ITEM # 3.0

PRELIMINARY & FINAL PLAT APPROVAL:

Tanglewood at Bentsen Palm Phase V
A tract of land containing 11.688 acres being out of Lot 14,
Del Monte Irrigation Co. Subdivision
PUD (R1)
Developer: Rhodes Enterprises, Inc.
Engineer: Melden & Hunt, Inc.

MAP OF TANGLEWOOD AT BENTSEN PALM PHASE V

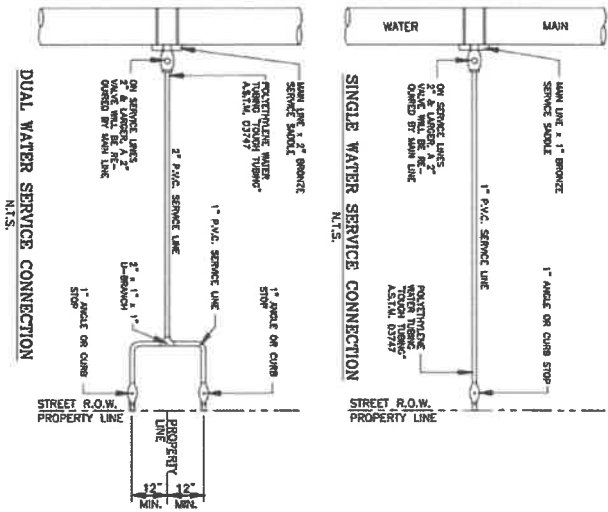
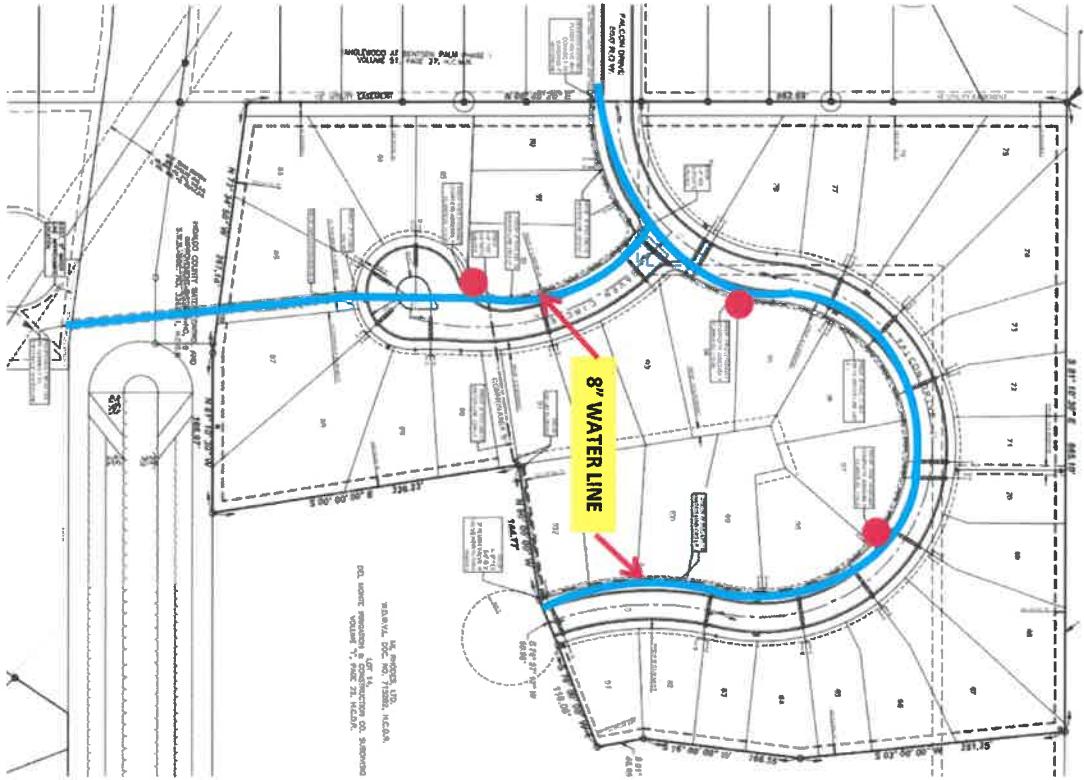
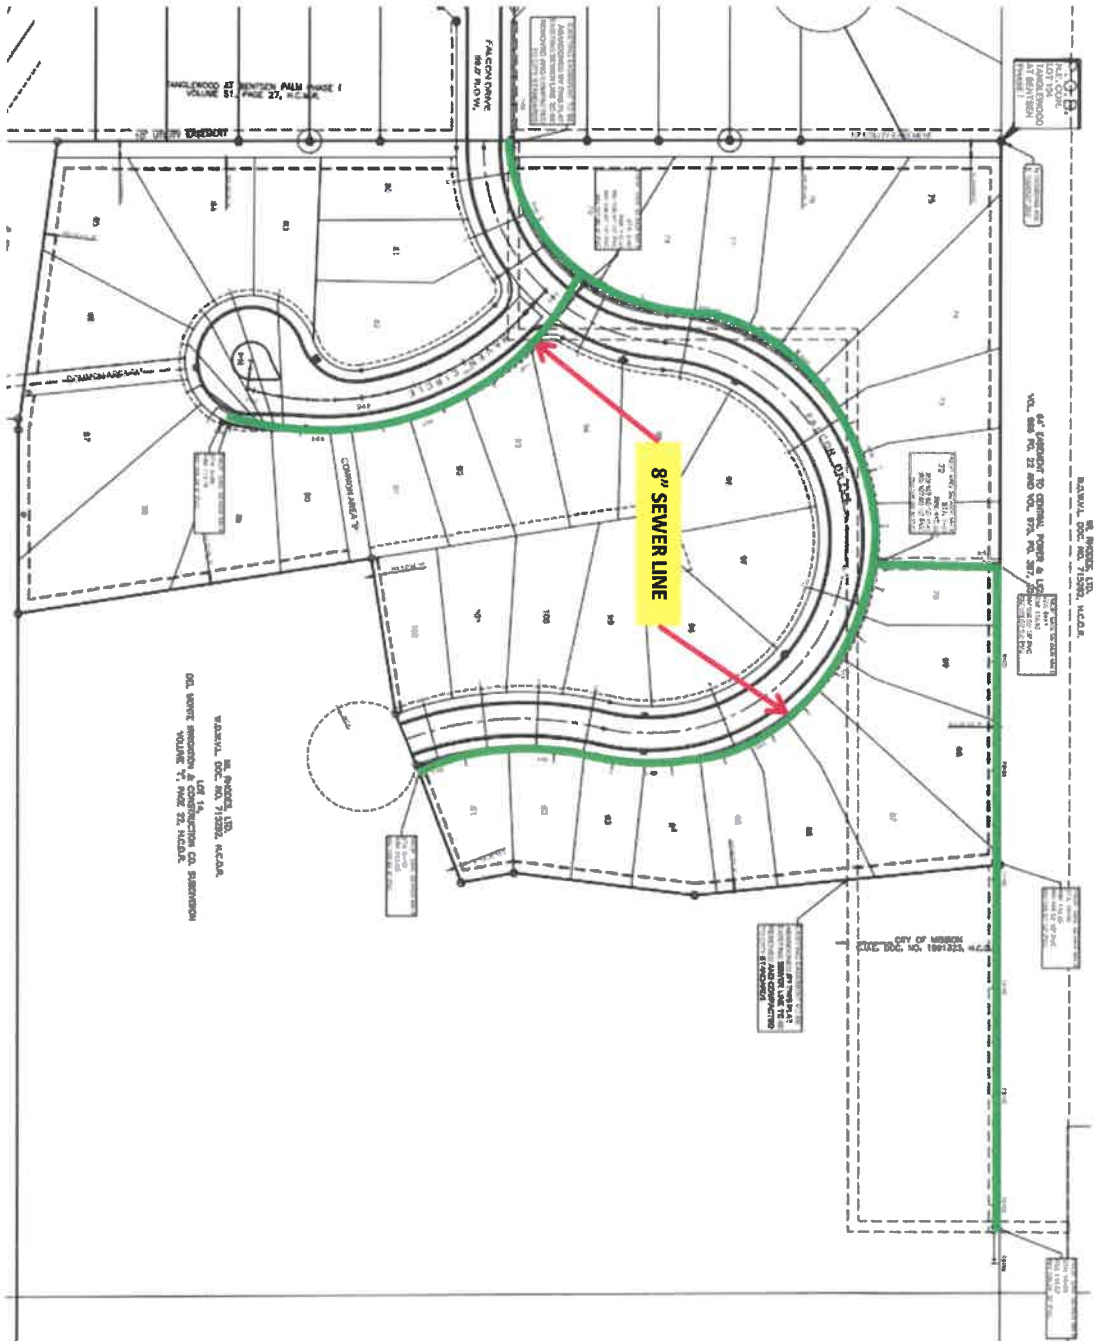
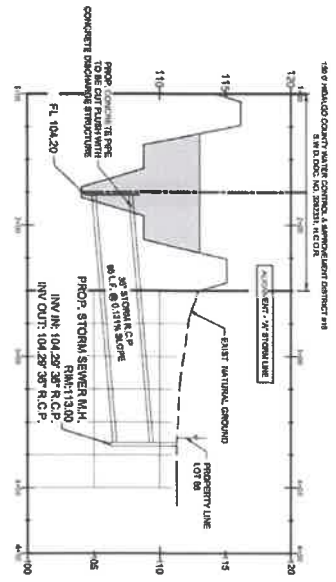
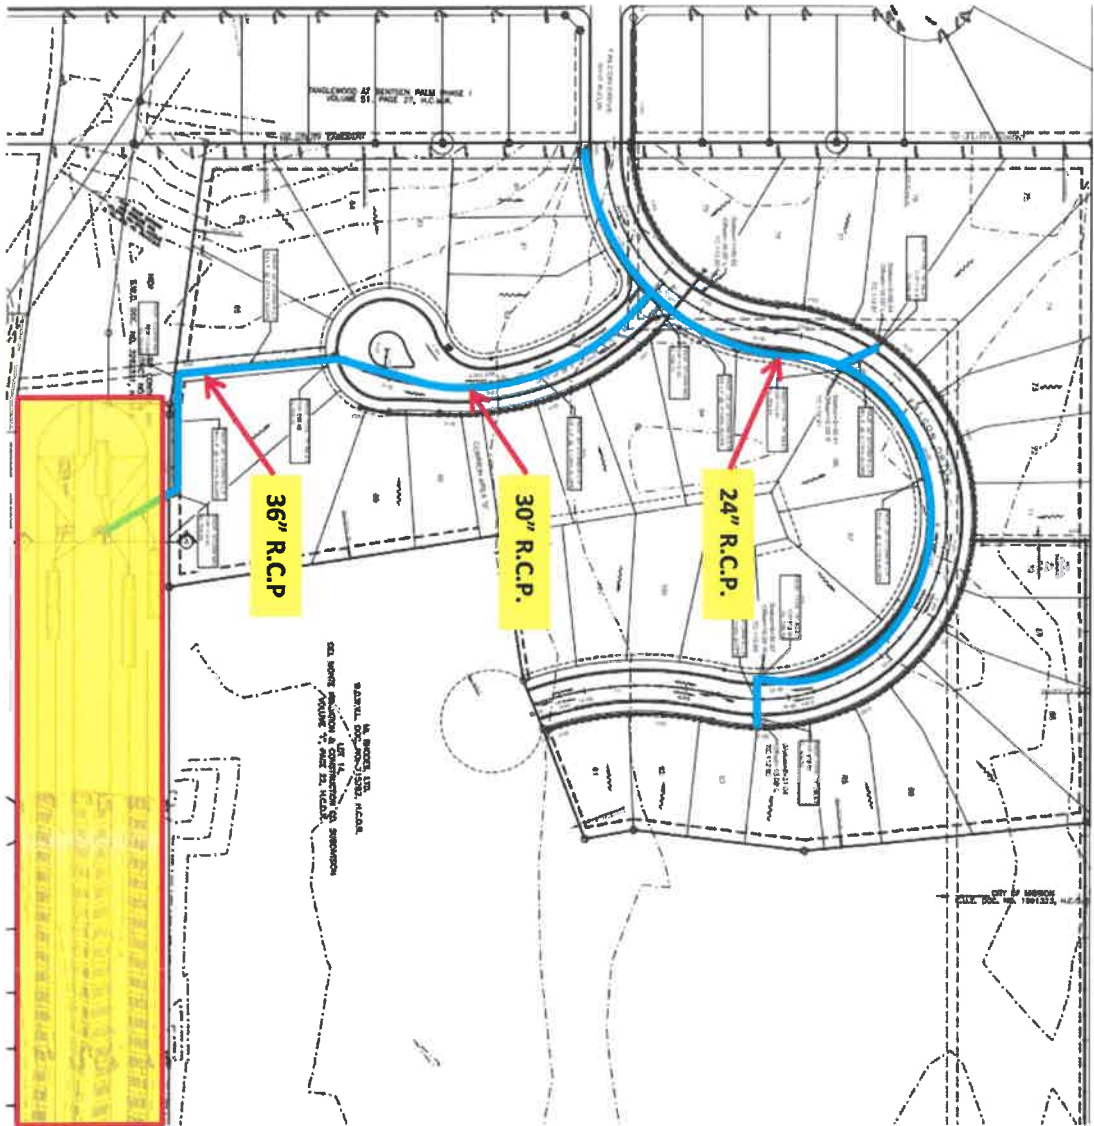
WATER: The developer shall connect to an existing 8" water line located along the South ROW of Falcon Drive within Tanglewood Phase IV which ended with a flush valve. The flush valve will be removed and a line will extend into the proposed development with a new 8" water line to provide water for each lot by a 1" service. There are 3 proposed fire hydrants via direction of the Fire Marshal's office.

SEWER: The developer is proposing an internal 8" sewer line system to provide sewer service to all the lots as it ties into an existing 8" sanitary sewer line along the North side of Falcon Drive being a continuation from Tanglewood Phase IV. This system will extend and also connect to an existing line NE of this proposed site. The Capital Sewer Recovery Fee is required at \$200.00/Lot which equates to \$8,400.00 (\$200.00 x 42Lots).

STREETS & STORM DRAINAGE: The proposed internal streets will be 32' back-to-back within a 50' Right of Way. Access will be from Falcon Drive.

The proposed drainage for this subdivision shall consist of surface runoff from the lots into the proposed streets and collected by type "A" inlets located at key points within the subdivision. The pipe size diameters shall range from 24" to 36". The proposed storm system shall discharge into an existing H.C.I.D No. 18 drain ditch, which was widened by phase III to accommodate future phases. The section of the H.C.I.D. No. 18 drain ditch, as included in Drainage Basins 38 and 43, discharges thru a 5'x5' box culvert under the Mission Main Canal, and has an ultimate outfall into the Mission Pilot Channel of the H.C.D.D. No. 1 System. The City Engineer has reviewed and approved the drainage report.

Water District Exclusion

Conveyance or Payment of Water Rights

No Park Fees – Mike Rhodes dedication of park land still stratifies the park Dedication Ord.

Installation of street lighting as per City Standards

Staff recommends approval subject to:

1. Payment of Capital Sewer Recovery Fees
2. Provide Water District Exclusion, and
3. Conveyance or Payment of Water Rights
